**CITY OF ALLENTOWN**

**R45 – 2024**

**Certificate of Appropriateness for work in the Historic Districts:**

**Allentown Historical Architectural Review Board  
FINAL Review Sheet**

**Side facade with chimney at 1142 Emmett Street  
(applicant)**

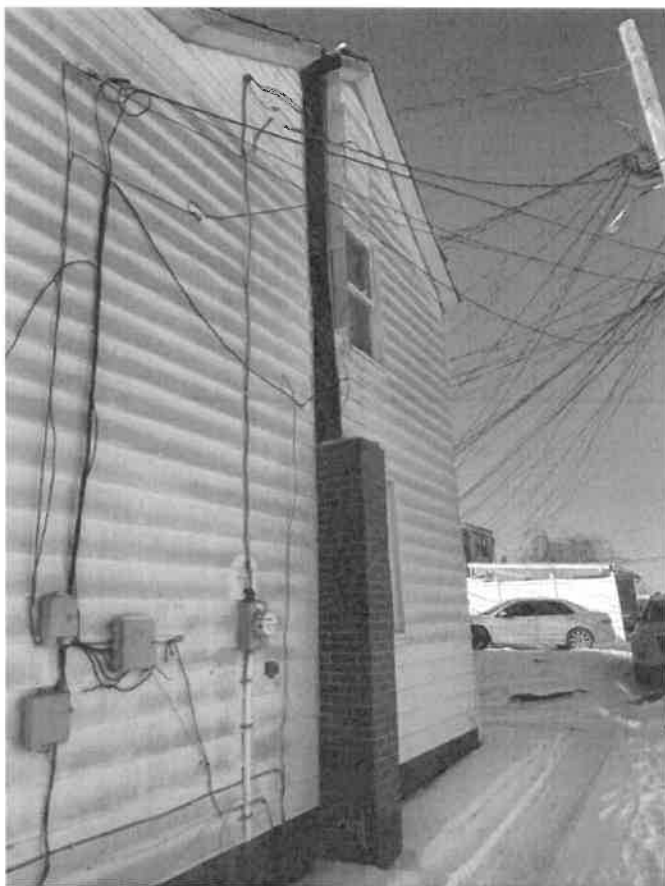
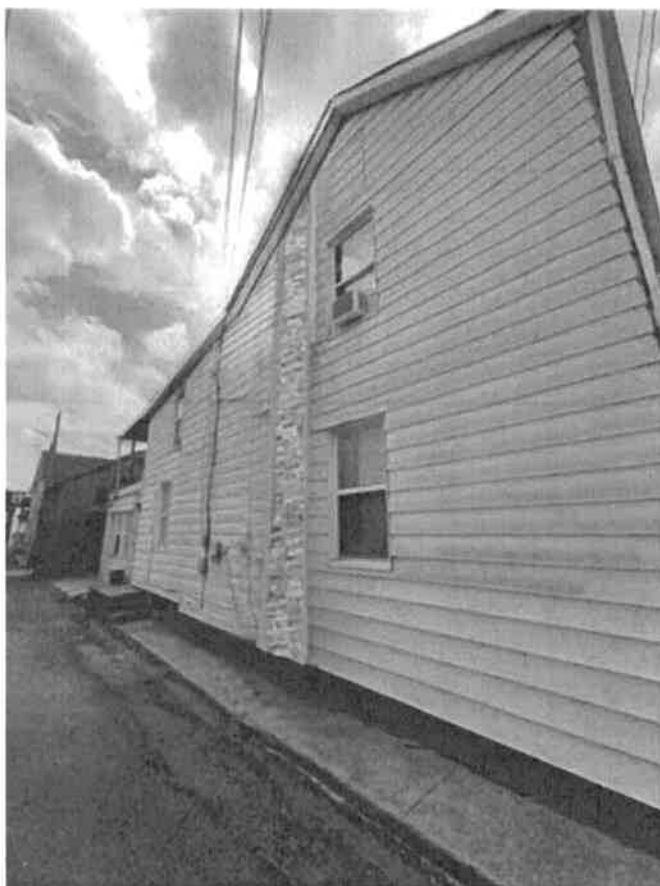
**Observations & Comments:** The chimney proposed to be removed is not original to the building. It was pulling away from the building at the top and is currently partially removed. Its removal should not be an issue since it was not original to the house and because it encroaches on the public sidewalk. The question is how to infill the gap in the siding when removed. The applicant's proposal to infill with stone is not historically appropriate. It may be appropriate to infill with brick instead or to cover the area with new siding that ties into the siding on one of its sides.

**Staff Recommendation:** It is recommended to approve either infilling the area with brick or infill the area with new siding that ties into the siding on one of its sides.

**240 ½ Hall St Front  
(applicant)**

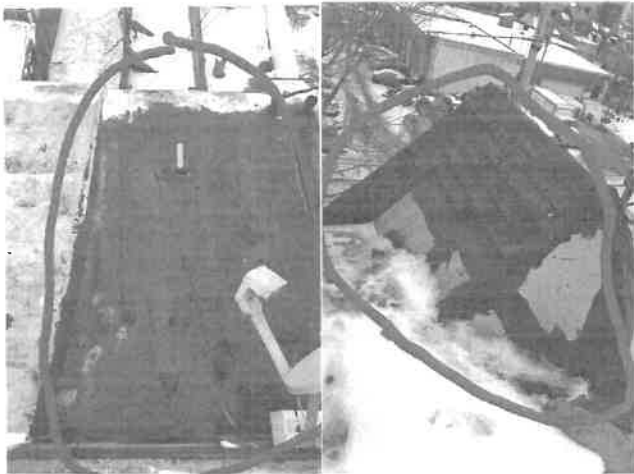
**Observations & Comments:** The upper flat roof areas proposed to be replaced with rubber membrane roofing are not visible from the public ROW, however the edge metal will be visible. The upper edge of the Mansard is currently covered with loose aluminum flashing. It is not known if the historic wood molding (seen on the neighboring property) is still extant. The aluminum flashing piece should be removed and the molding repaired or replaced in-kind and painted. The membrane roof edge should match the trim color (white)

The replacement of the existing 3 tab asphalt/fiberglass shingles on the Mansard and one side of the dormer gable is historically appropriate if the shingles are 3 tab shingles to match existing in style and color or GAF Slateline shingles in the Antique Slate color or equivalent. The proposed architectural shingle does not recall slate and is not supported by the Design Guidelines. The replacement of flat seamed metal roofing on the front and rear porches is also proposed. The surface of the front porch roof is hard to see from the street, the rear roof is visible from Emmett St. which is a short narrow alley. The proposal to replace the metal roofing with shingle is not historically ideal but other nearby or adjacent roofs have been replaced with asphalt shingles. Because of the lack of visibility of the front roof and the low level of visibility of the rear roof, the HARB should consider replacement with 3 tab shingles to match the existing Mansards or with GAF Slateline shingles.

The built-in gutter at the third floor needs to be repaired in kind and the box gutter relined to extend its use. The K gutter at the front porch is shared with the neighbor. It should be repaired and replaced in kind or replaced with a more historic half-round gutter. Adequate hangers must be used to deter failure.

**Action:** Mr. AJ Jordan moved to approve, with conditions, the application presented on March 4th, 2024, replacement of roofing at 204.5 Hall Street, pursuant to Chapter 3, Section 3. Chapter 3.1 – Roofs. The following conditions were agreed to by the applicant:

- The roof shingle will be GAF Slateline shingle in Antique Slate color or equivalent
- No gutter work will be done without review unless it is done in-kind.
- The porches will also be reroofed with the same GAF Slateline shingle.
-

**1109 W Turner St Front  
(applicant)**

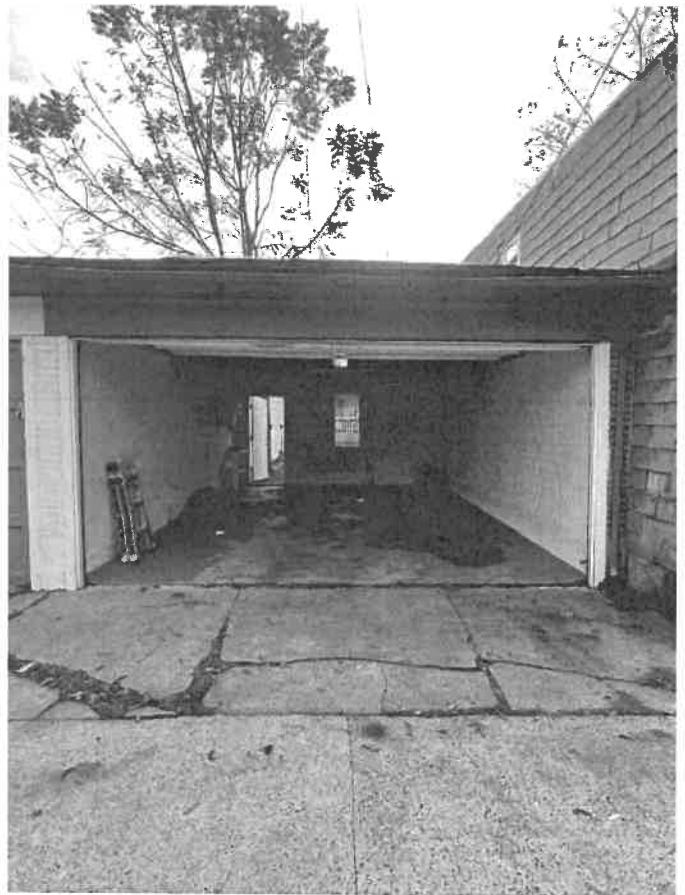
**Observations & Comments:** The proposed roof replacements are for flat roofs and the roof surfaces are not visible from the public ROW

**Staff Recommendation:** It is recommended to approve as submitted.

**Actions:** Mr. AJ Jordan moved to approve the application as presented on March 4th, 2024, to replace the roofing at 1109 W Turner Street pursuant to Chapter 3.1. The following conditions were agreed to by the applicant:

- The work follow the submitted scope as proposed.
